FREDERICK COUNTY PLANNING COMMISSION

TITLE: Hattery Farm, LLC, Section I, Lots 1-24

FILE NUMBER: S-1155, AP 12180 (APFO 12181, FRO 13235)

REQUEST: **Ag Cluster Preliminary Plan Approval**
The Applicant is requesting Preliminary Plan approval for a 24-lot Agricultural Cluster subdivision on a 317.77-acre property, including a modification to allow panhandle lots in a major subdivision.

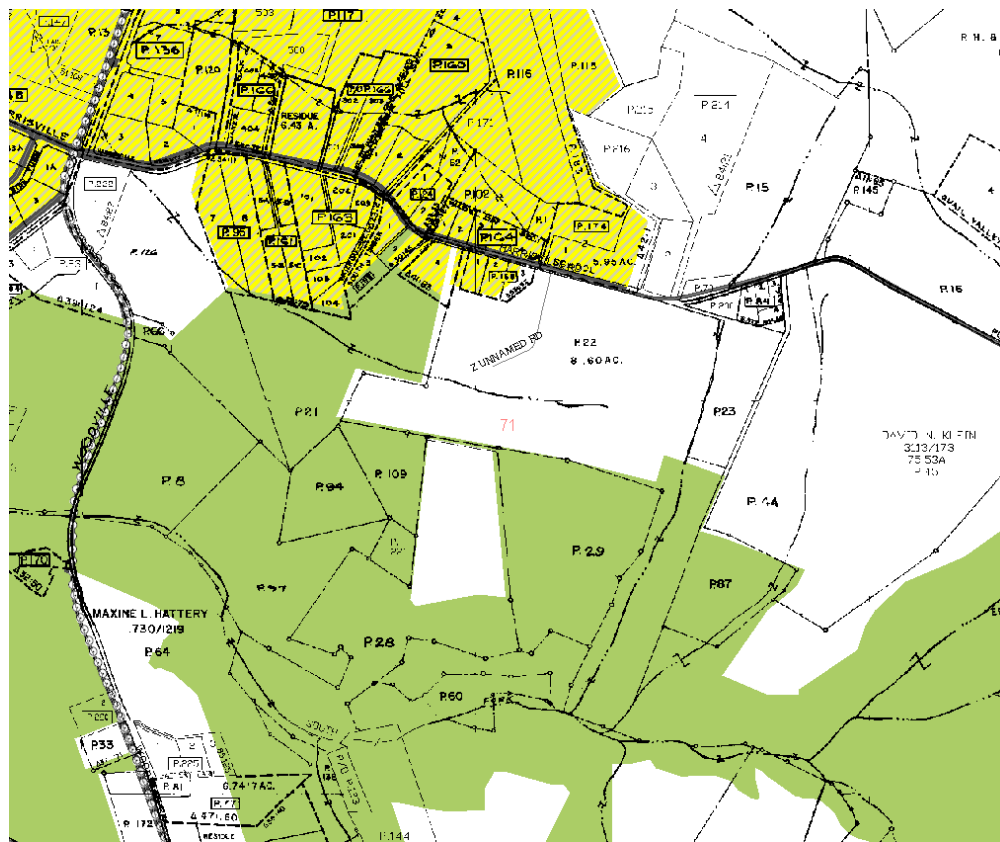
The FcPc determined that the approved Concept Plan met the purpose and intent of the Ag Cluster provisions. The differences between the approved Concept Plan and the Preliminary Plan are outlined in the table below. Due to increased lot area and street dedication, the Preliminary Plan layout utilizes 2.35 additional development acres than the Concept Plan. Though the overall differences are minor, the FcPc must determine that the Preliminary Plan design still meets the Ag Cluster provisions.

Lot Area	Street Dedication	Min. Lot size	Max. Lot size	Avg. Lot size	Total No. Lots	Total Area of Subdivision
Concept Plan	29.32	2.73	1.00	1.80	1.22	24	32.05
Preliminary Plan	31.10	3.30	1.00	1.85	1.40	24	34.40
Difference	+1.78 ac.	+0.57 ac.	0	+0.05 ac	+0.18 ac.	0	+2.35 ac.
